La Jolla Shores Planned District Advisory Board (LJSPDAB) APPLICANT PROJECT INFORMATION FORM

- Project Tracking System (PTS) Number/Accela "PRJ" Number and Project Name (only submitted projects to the Development Services Department can be heard as action items):
PRJ-1085883

- Address and APN(s):
8303 LA JOLLA SHORES DRIVE, LA JOLLA, CA 92037
APN(s): 346-250-0800, 346-250-0900, 346-250-1000
- Project contact name, phone, e-mail:
ANDY FOTSCH - WILL AND FOTSCH ARCHITECTS
858-224-2486
PERMITS@WILLANDFOTSCH.COM

- Project description:
 - **SITE DEVELOPMENT/COASTAL DEVELOPMENT/NEIGHBORHOOD DEVELOPMENT PLANS**
 - 1 CONSOLIDATED LOT SPLIT INTO 6 INDIVIDUAL LOTS
 - EACH LOT TO CONSIST OF 1 SINGLE FAMILY DWELLING

A215

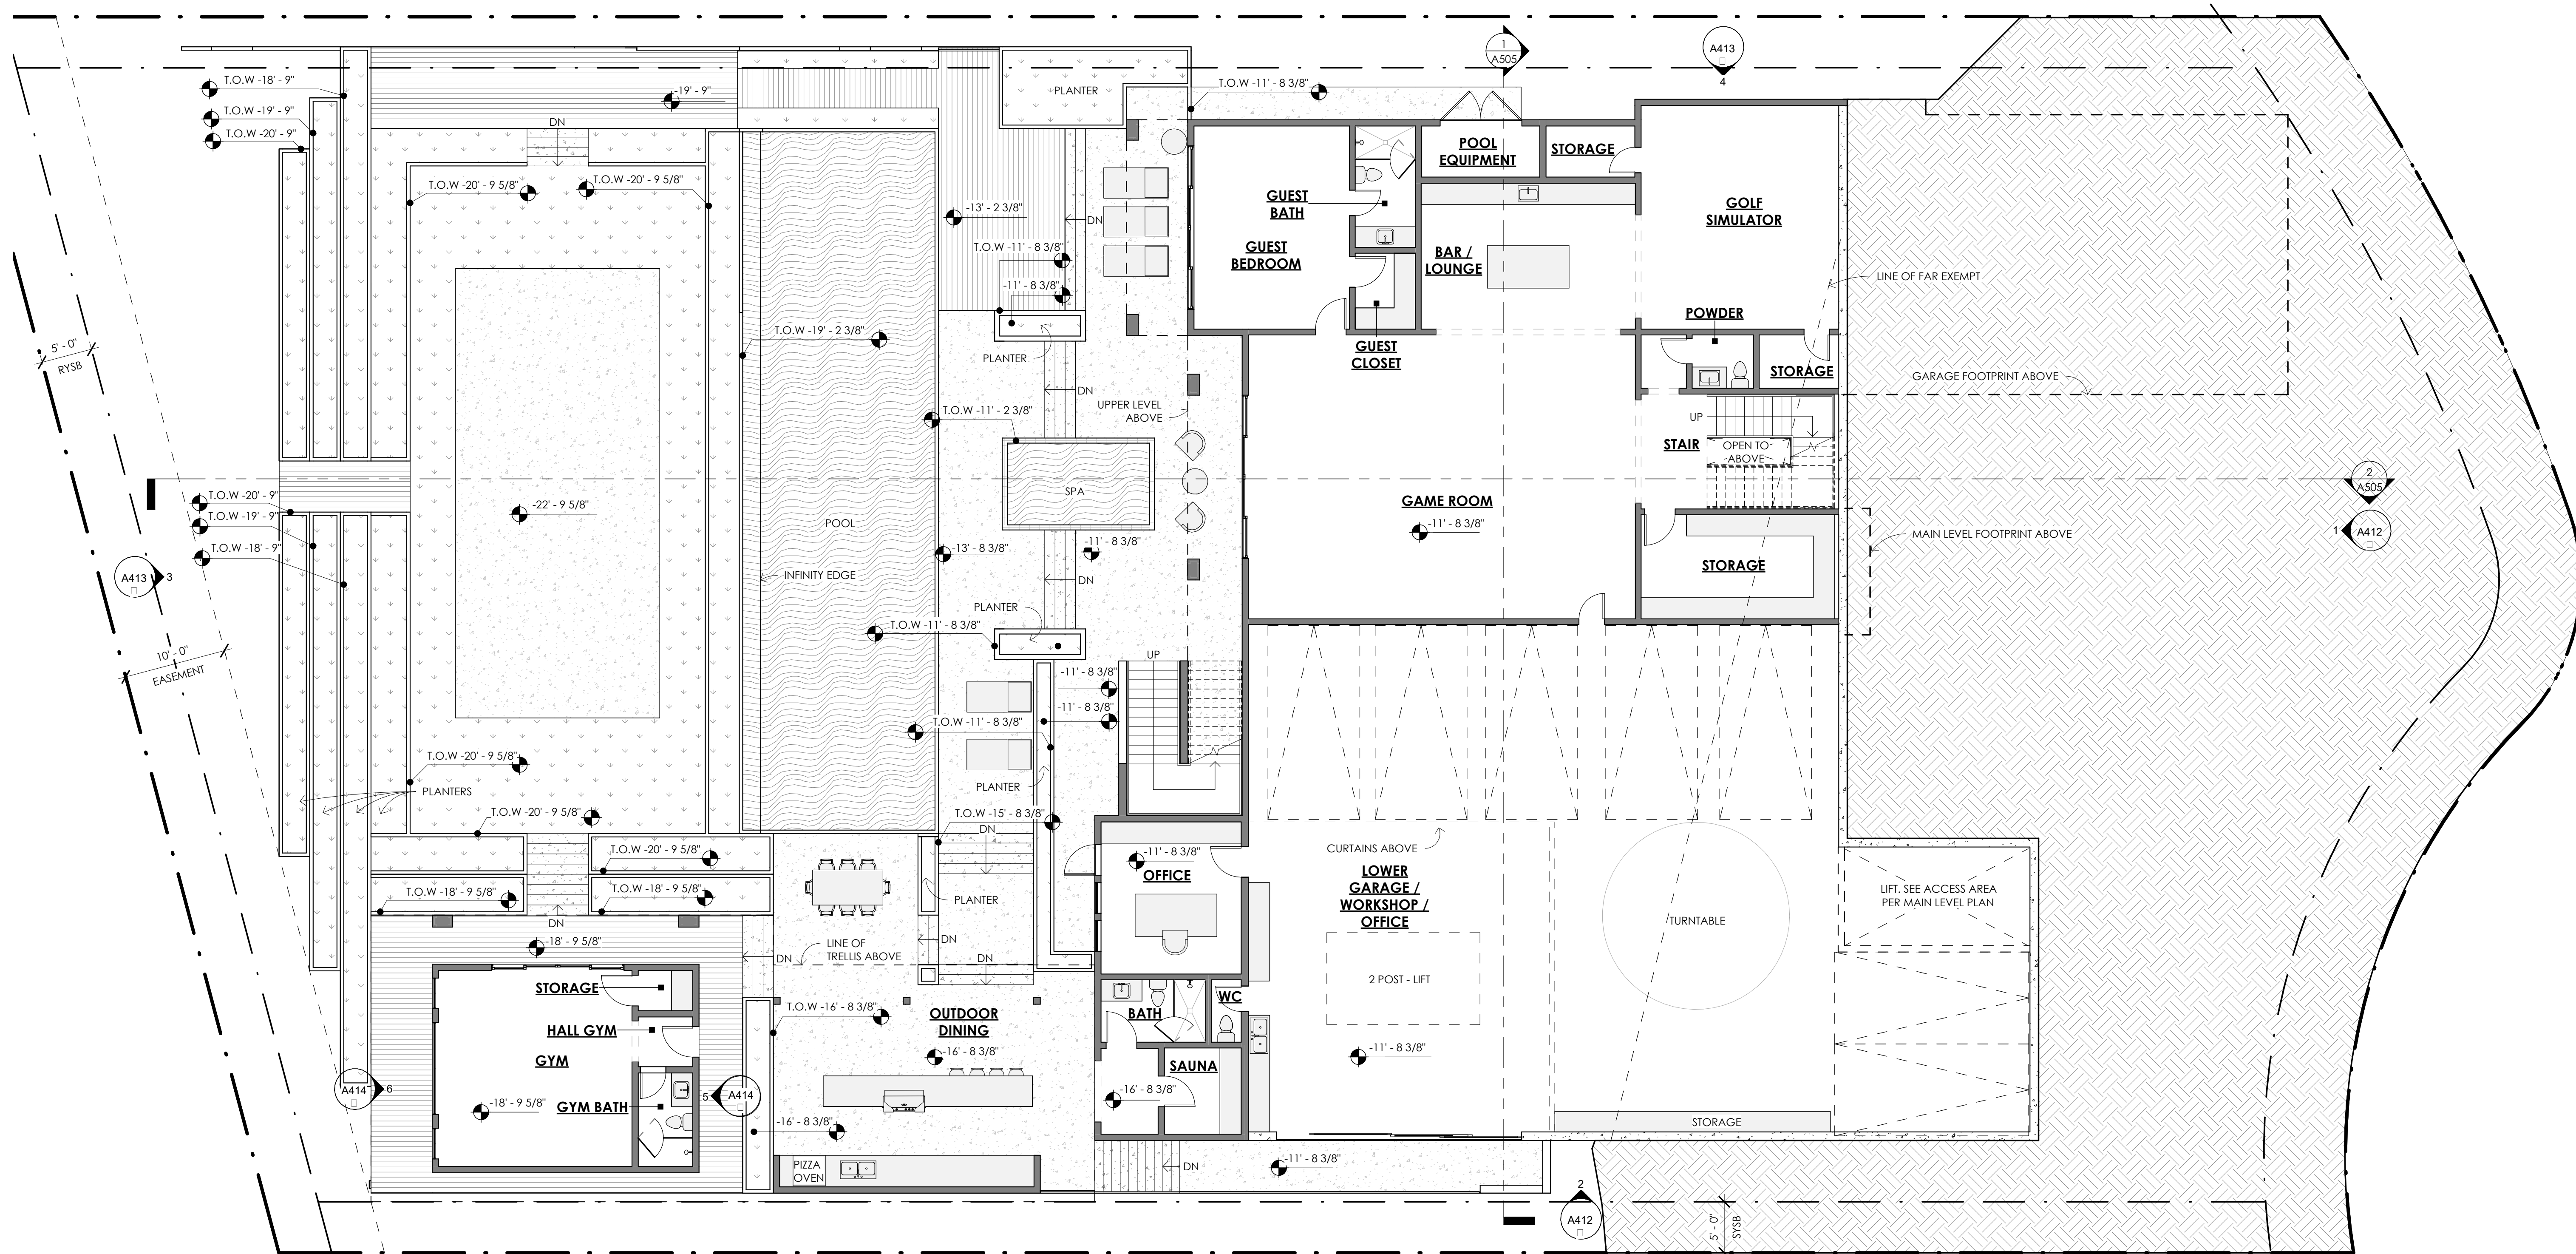
Sheet A215 shows a car turntable for Lot 5; please provide information on how this turntable will operate and how 5 cars can be parked in the garage without obstructing the turntable. In addition, Sheet A215 also shows an area labeled as lower garage/workshop/office and 2 post-lift; please provide information on how the 2 post-lift will operate and demonstrate and clarify how it would not obstruct access to the parking spaces within the garage.
